Re: Railway (Metrolink - Estuary to Charlemont via Dublin Airport) Order [2022]
Metrolink. Estuary through Swords, Dublin Airport, Ballymun, Glasnevin and City Centre to
Charlemont, Co. Dublin

Subject: Application by the National Roads Authority (operating as Transport Infrastructure Ireland) for the Railway (Metrolink–Estuary to Charlemont via Dublin Airport) Order [2022] Case Number: NA29N.314724

RE: SUBMISSION ON THE METROLINK RAILWAY ORDER APPLICATION IN
RELATION TO THE SITE OF A COMMERCIAL DEVELOPMENT AT 2 GRAND
PARADE, RANELAGH, DUBLIN 6.

RAILWAY ORDER
Charlemont Station Observation

Figure 4: Extract from plan number ML-P 307 O-A (Railway Works MetroLink- Property Details Grand Parade to Northbrook Road)

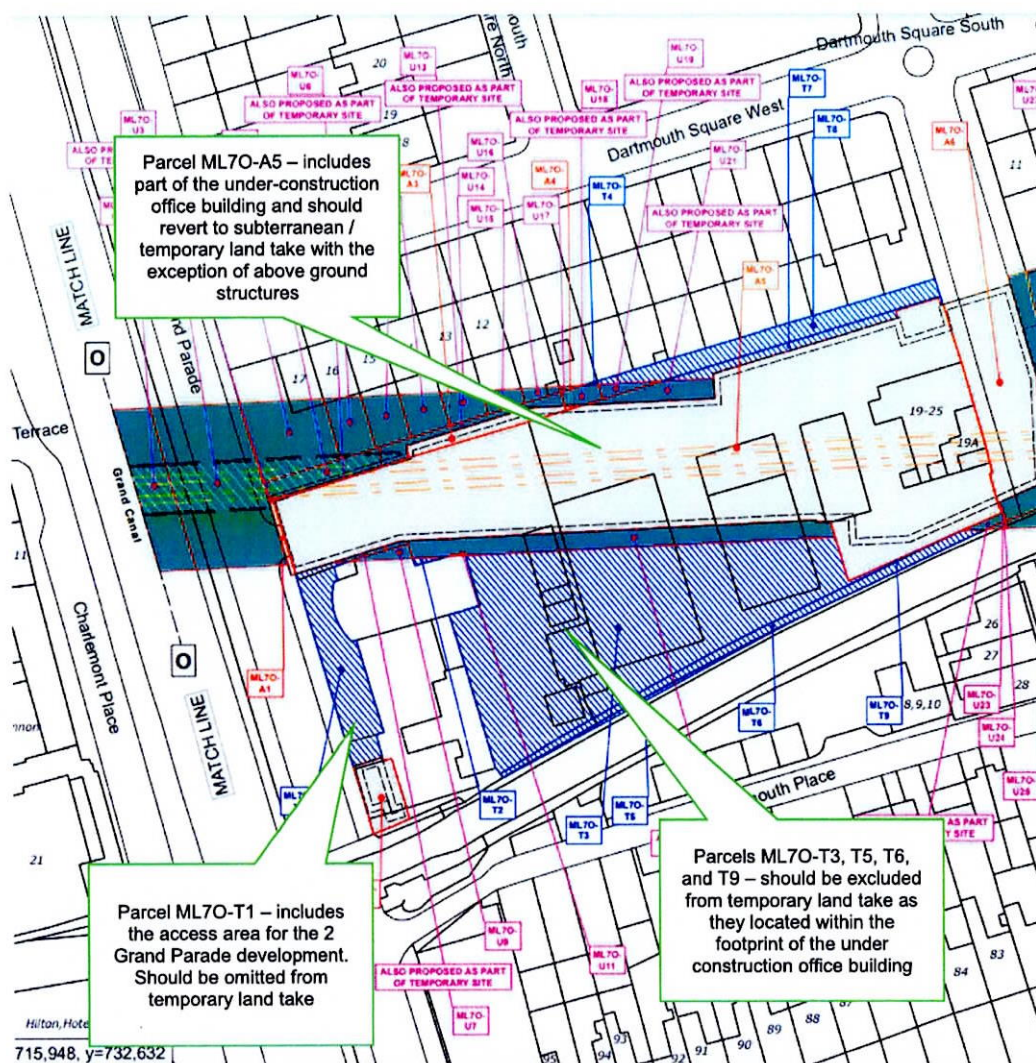
As noted in the figure below, parts of the permanent and temporary land take illustrated at 2 Grand Parade actually fall within the built footprint of the office development which is nearing completion on site (as permitted under Reg. Ref.: 2372/17 / ABP Ref.: 300873-18, as amended by Reg. Ref.: 4755/19 and Reg. Ref.: 3486/20 / ABP Ref.: 309011-20). Therefore these areas of the site are not suitable either for temporary or permanent acquisition.

It is submitted that the extent of permanent land take should be revised to take in only the elements of ground-level development proposed as part of the Charlemont station (i.e. escalators, vents, station building etc.).

Similarly, the temporary land take should be reduced to cover areas which will actually be required (and available) for use during the construction phase. This must exclude the footprint of the office building under construction and nearing completion on site, along with any lands necessary to maintain the access, underground services and operation of the office development.

Figure 5: Extract from 2GP Permitted Planning Drawing 950231 PL1010 Reg. Ref.:3486/20, with the location of the lift and stairway indicated in blue and fire escape routes denoted by green arrows

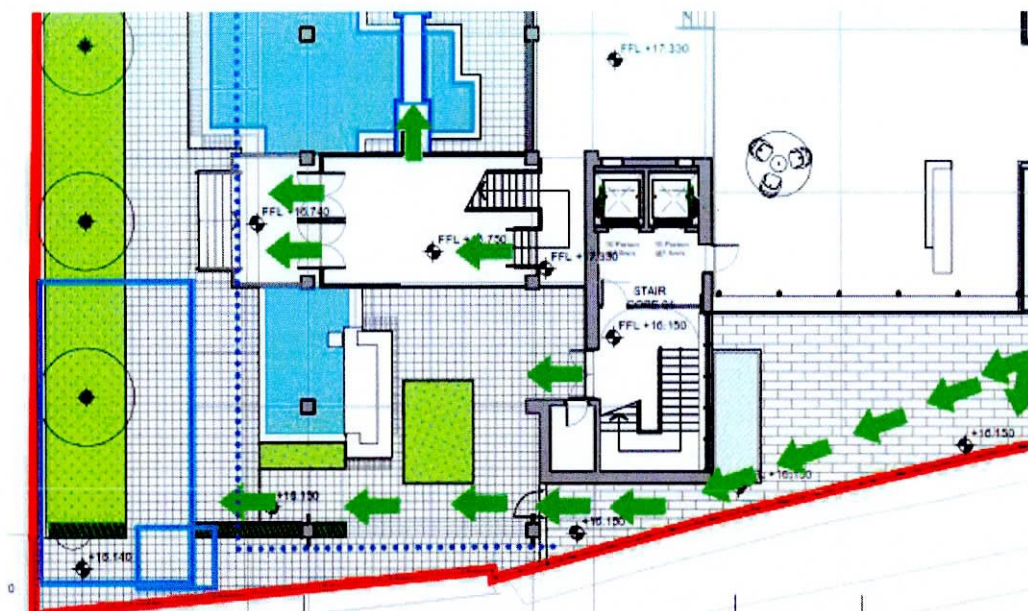
- The structure would obstruct designated fire escape routes from the 2 Grand Parade development,
- There would be an additional risk of fire spread in the event of a fire due to proximity to the existing building.

- Additional information needed in relation to pedestrian traffic flow and capacity for both normal and evacuation scenarios.
- The stairway and lift shaft will negatively impact on the appearance and setting of the Carroll's Building, a protected structure which is integrated into the 2 Grand Parade commercial development.
- The stairway and lift could give rise to privacy issues within the adjacent office building.

Having regard to the foregoing, it is submitted that the lift shaft should be relocated to an alternate location (potentially the opposite side of Grand Parade adjacent to the Grand Canal) and the staircase proposed should be reconfigured to address the concerns raised.

Figure 6: Extract from 2GP Permitted Planning Drawing 950231 PL1010 Reg. Ref.: 3486/20, with the location of the proposed escalators and extent of access road in blue, and fire escape route denoted by green arrow

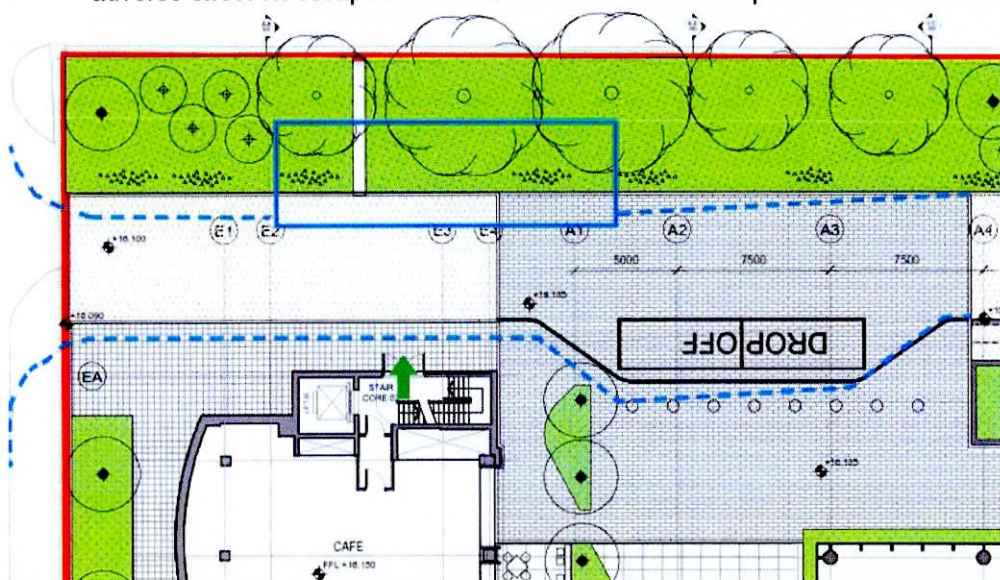
- Part of the permitted 2 Grand Parade scheme is a 6m roadway to access the development (with the width of the access based on two-way car traffic, fire access, cyclists, and to accommodate perpendicular parking). The escalators proposed would reduce the width of the access to an extent which would interfere with the accessing of the development.

- This will also result in the realignment of the internal access road and of the main vehicular executive Drop-Off, impacting on the landscaped atrium plaza and alignment with the building entrance configuration, and on the removal of 5 no. existing trees adjacent to Dartmouth Lane (the eastern boundary of the site).

- The design currently does not indicate a kerb along side the escalators (which would be required) and this would further obstruct the access to the 2 Grand Parade development.

- In addition to this, the MSA note states that this aspect of the design would have an adverse effect on escape from the 2 Grand Parade development via stair core 2.

Having regard to the foregoing, revisions should be made to the Railway Order application drawings and documents, to ensure that a minimum 5.5 metre carriageway and a 2-metre paved footpath to maintain adequate access (including fire access).

Figure 2: Extract from drawing ML1-JAI-SRD-ROUT_XX-DR-02090

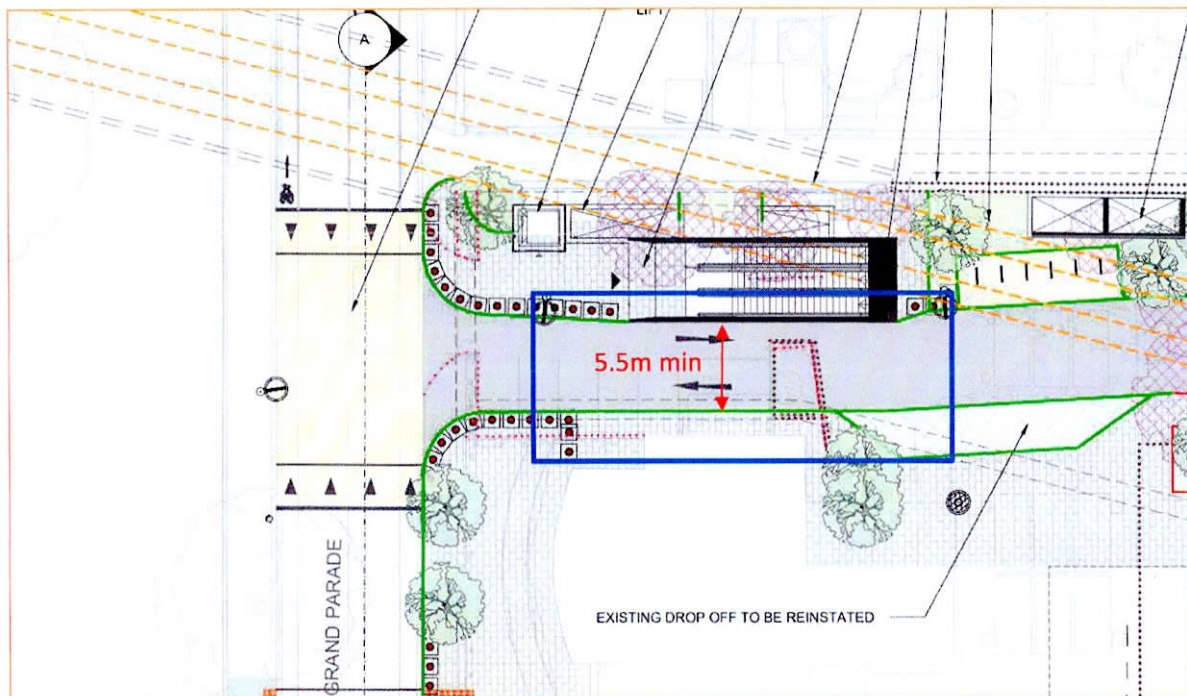
Refer to HJL observation number 1 'Grand Parade Entrance Escalators' regarding the alterations to the access to the commercial development from Grand Parade. The size and location of the escalators is such that alterations to the access road are proposed to accommodate them. It is noted that as part of the permitted scheme for 2 Grand Parade a 6m wide access road is required to allow access for 2 vehicles to pass each other. This road is proposed as 4m wide following the completion of the Metrolink development (refer to figure 3) which is insufficient for 2-way traffic. The minimum width considered acceptable is 5.5m clear from inside face of kerbs. The Railway Order drawings and documents should be revised to reflect this width.

A raised traffic table is proposed at the entrance to the property from Grand Parade as shown on figure 2. This alteration will result in changes to the access road levels and permitted drainage strategy and as such further information is required to assess the implications of this aspect of the design.

Figure 8: Extract from A5.3 'Construction Sequence report' pg 152

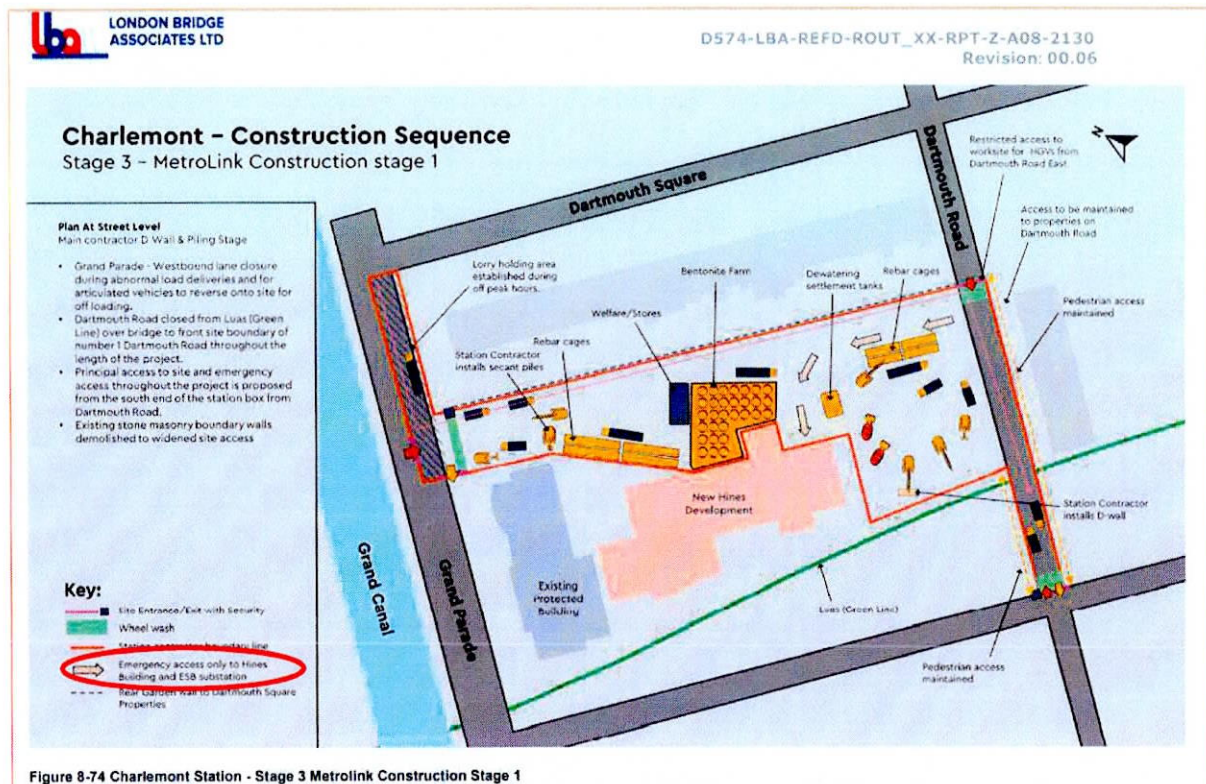
There are 2 proposals outlined for Charlemont station from page 150-165 in Appendix A5.3 'Construction Sequence Report' within the EIAR. The first option entitled '*Charlemont – Construction Sequence*' describes a methodology that does not allow for any access (other than emergency) to the basement of 2 Grand Parade during the construction period and is considered unacceptable by our client (refer to example in figure 8).

Note that our client will require 24 hour unimpeded access for vehicles and cyclists to the basement, plant areas and ESB substation.

Fig 01A Extract from submission drawing ML1-JAI-ARD-ROUT_XK-DR-Y-02090

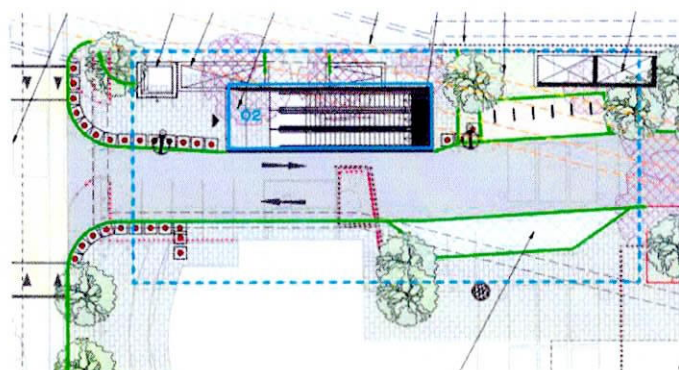
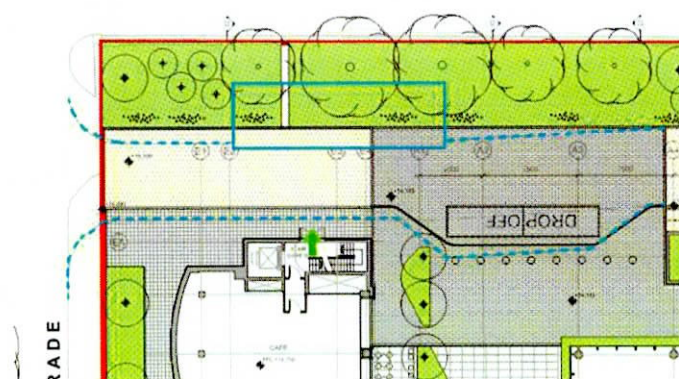
1. The Railway Order drawings do not appear to have taken cognisance of the following items.
 - a. *The proposed reduction in roadway width to the East of the 2 Grand Parade building and the adverse effect this has on escape from the building via core 2, and fire service vehicle access along the east Elevation of the building.*

Fig O2A Extract from submission drawing ML1-JAI-ARD-ROUT_XX-DR-Y-02090

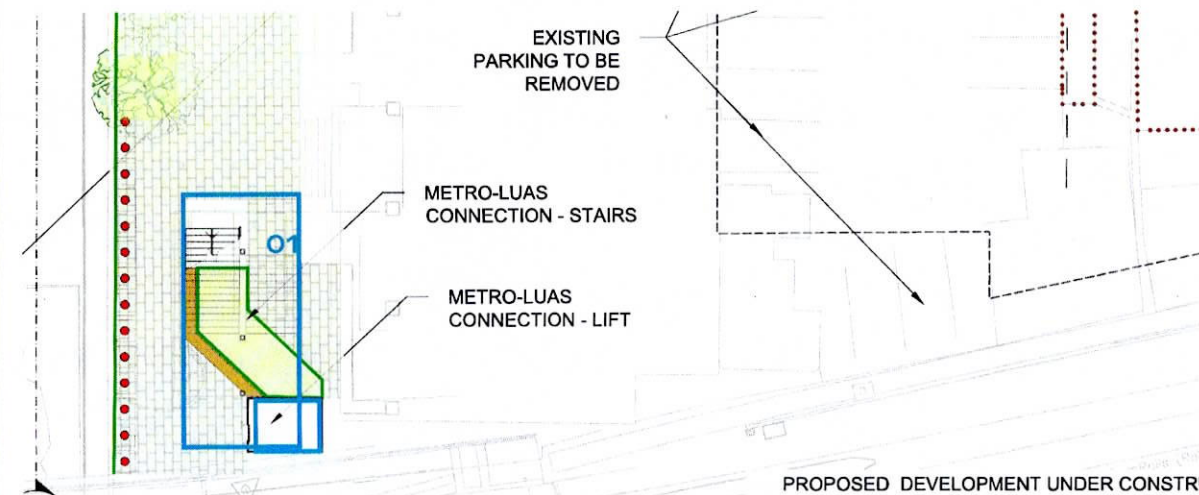
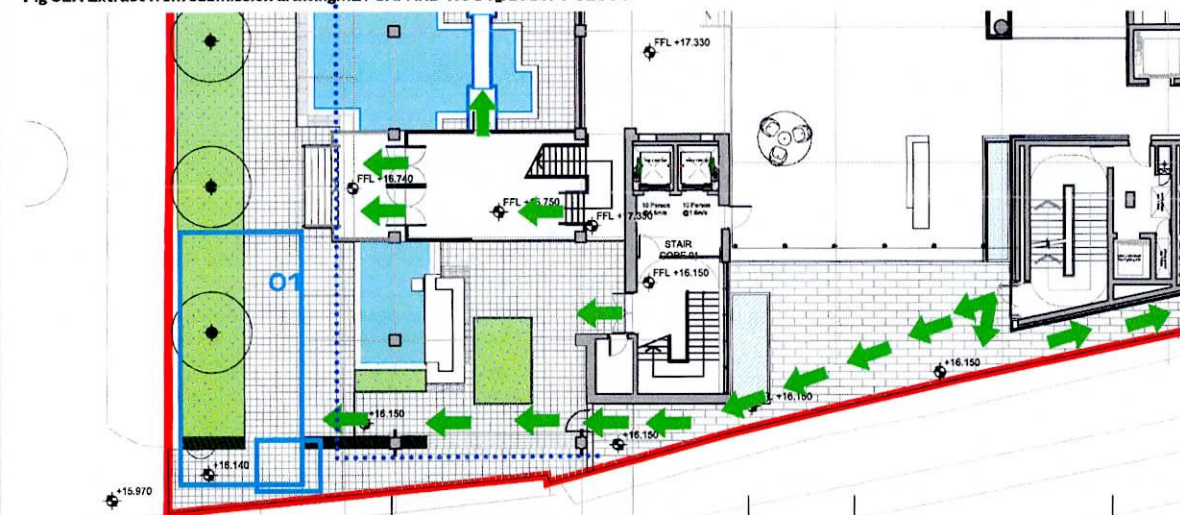
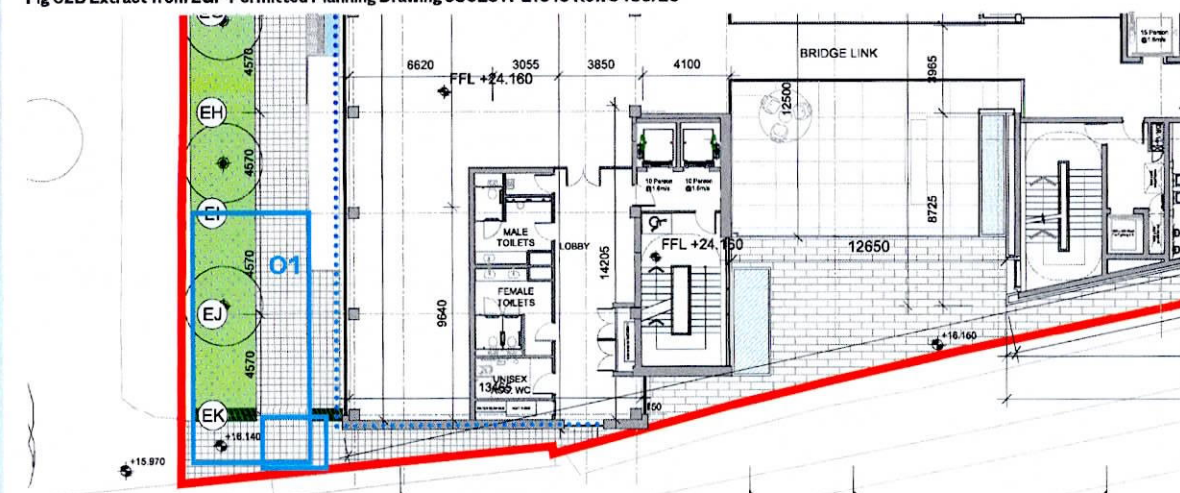
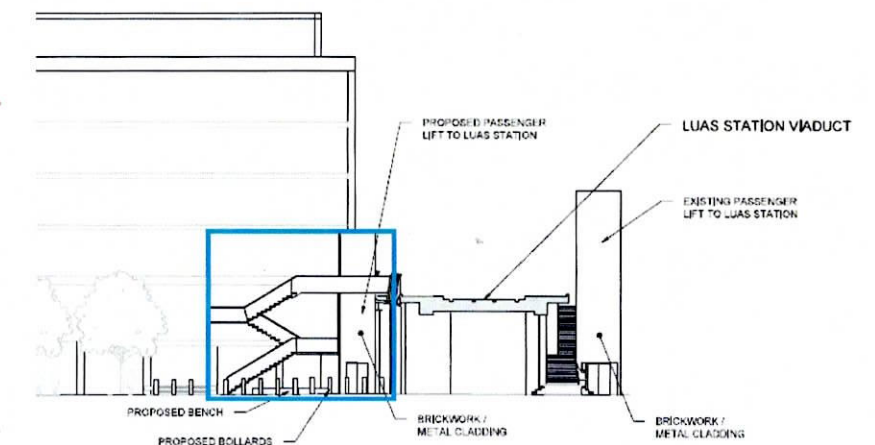
- There will be privacy issues with the pedestrian route from the lift and stair passing directly past the office windows - see Fig O2C.

In Fig O2B, the proposals for the luas link lift and stair are outlined in blue on the 2GP site layout plan to assist in demonstrating the close proximity of the proposals to the 2GP building and the impact it would have on a main fire access and egress route linking the 2GP escape stairs directly through the proposed stair and lift location to the road at Grand Parade.

In Fig O2C, the proposals for the luas link lift and stair are outlined in blue on the 2GP second floor plan to assist in demonstrating the close proximity of the proposed lift and stair to the glazed facade of the 2GP building.

The lift and stair configuration as proposed are a concern to the 2GP development and at a minimum we suggest the relocation of the lift to an alternative location, potentially to the opposite side of the Grand Parade road adjacent to the canal, and the reconfiguration of the staircase to address the observations noted above.

Fig 01A Extract from submission drawing ML1-JAI-ARD-ROUT_XX-DR-Y-02090

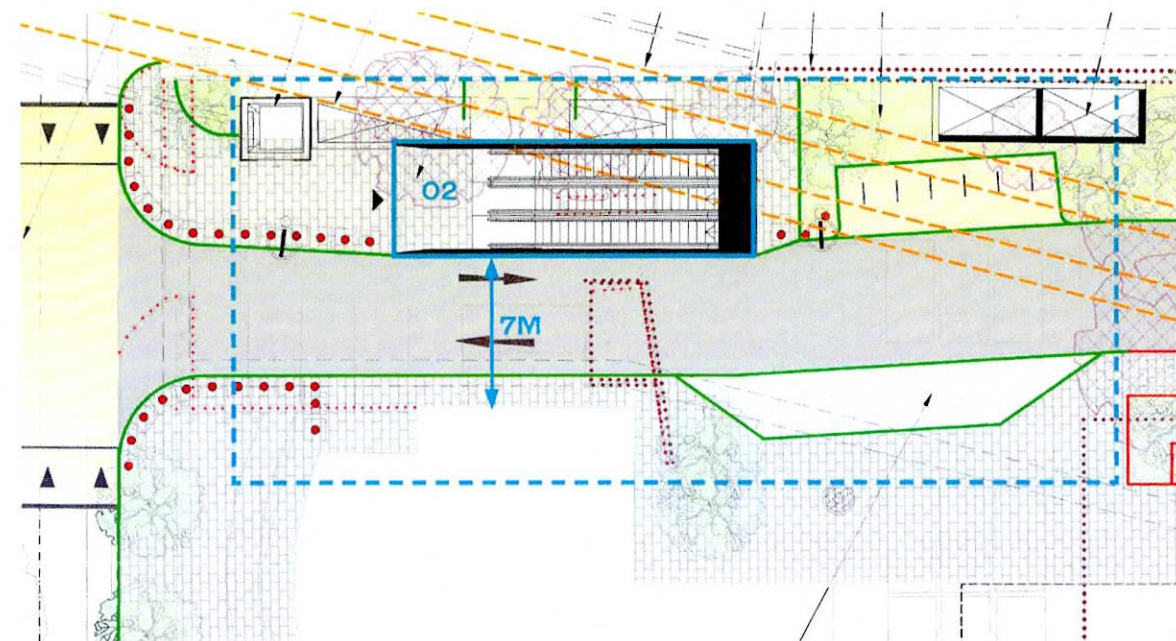
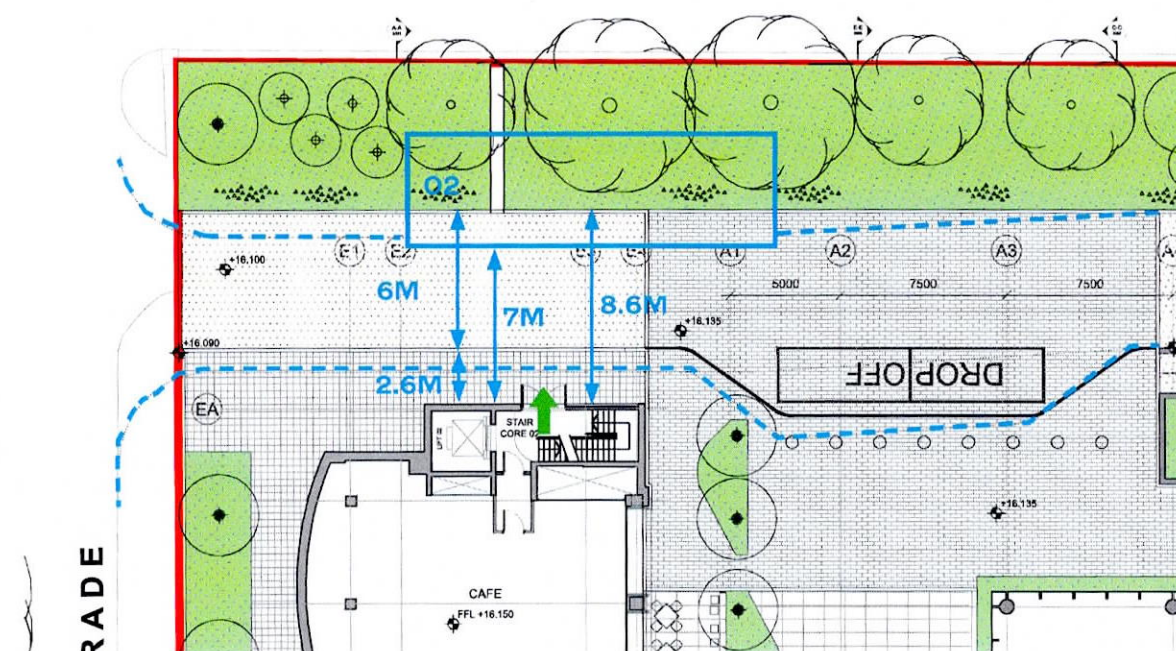
This would also allow the parallel Drop-Off zone configuration to be maintained. Our client would be concerned that anything less than this provision would curtail the operation of the permitted development currently under construction on site.

In addition, there are 5 no. trees that are protected under the 2GP planning permission located along the Dartmouth Lane perimeter that will be impacted by the proposals that will need consideration. We request that the location and design of the escalators and the lift be considered further, and amendments introduced prior to the granting of a railway order.

In Fig 01B, the metro proposals for the escalators and roadways are outlined in blue on the 2GP site layout plan to assist in demonstrating the impact of the proposed reduction in the road and paved zone widths and splayed Drop-Off zone.
